REF. NO. C24000085

**REPLACEMENT OF
FUEL TANK CONNECTING PIPE**

MODEL YEARS 2022 - 2023

June 2023

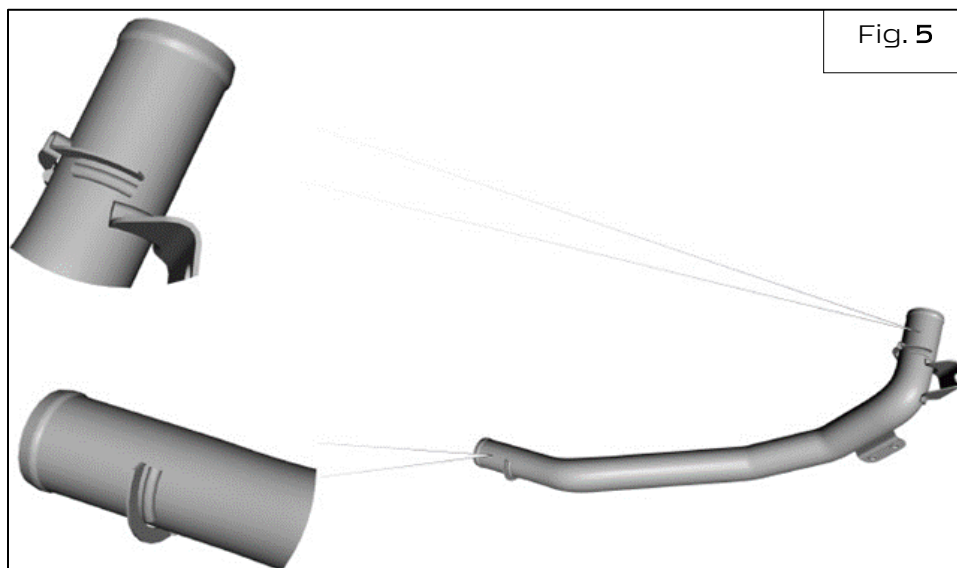
- Take the new fuel tank connecting pipe and apply lubricant **CB 2164** to the two ends of the pipe - Fig. 5.

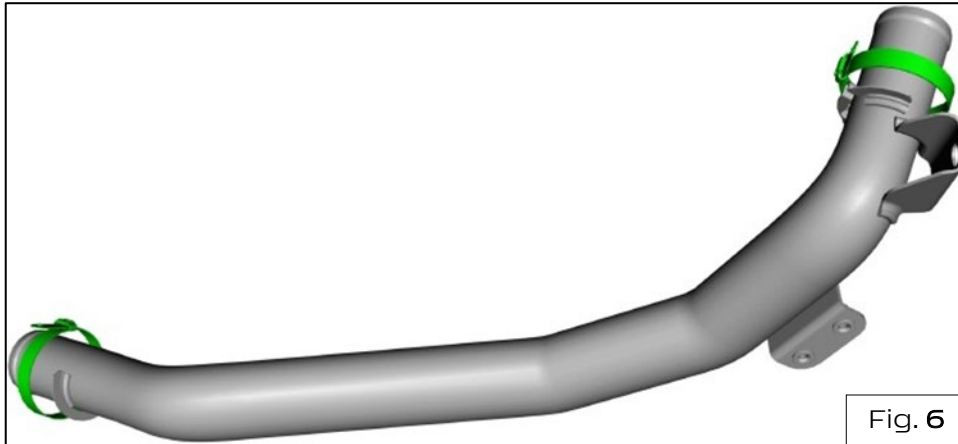
- Place two new screw collars Ø35-45mm on the connecting pipe – Fig. 6.

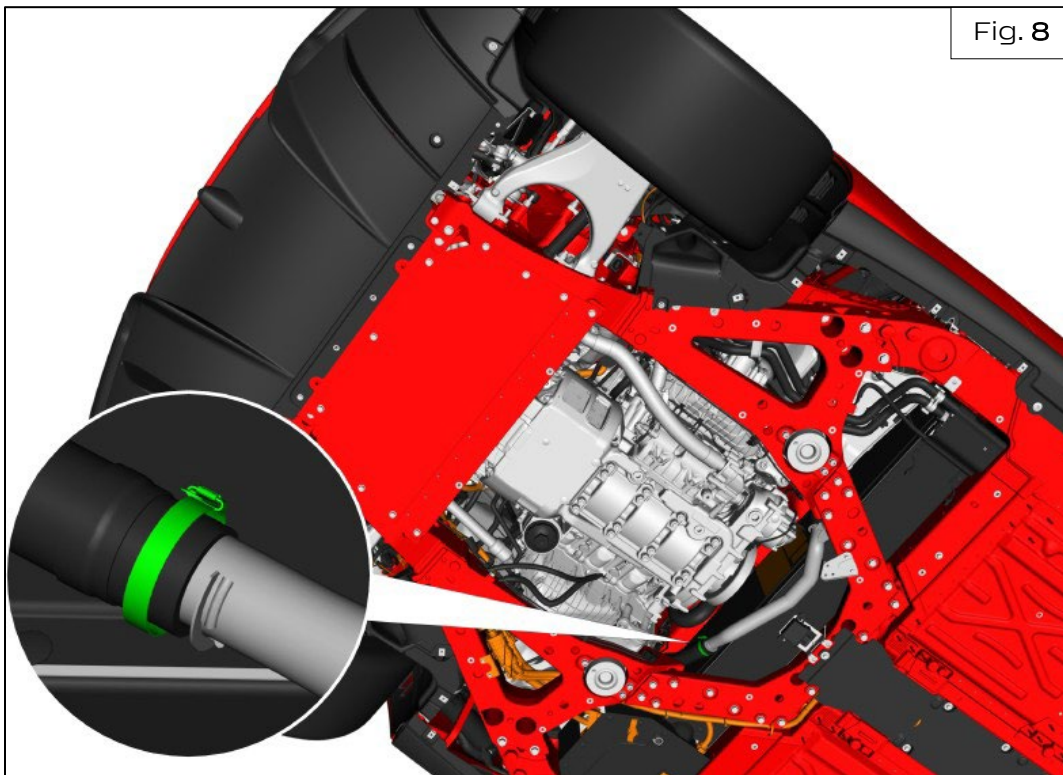
Make sure that the notch on the RH side of the pipe is aligned with the slot on the RH hose.

Make sure that the LH end of the pipe is inserted in the LH hose up to the MIN sign indicated on the pipe.

- Tighten the indicated screw collar to a torque of **4 Nm** - Fig. 8.
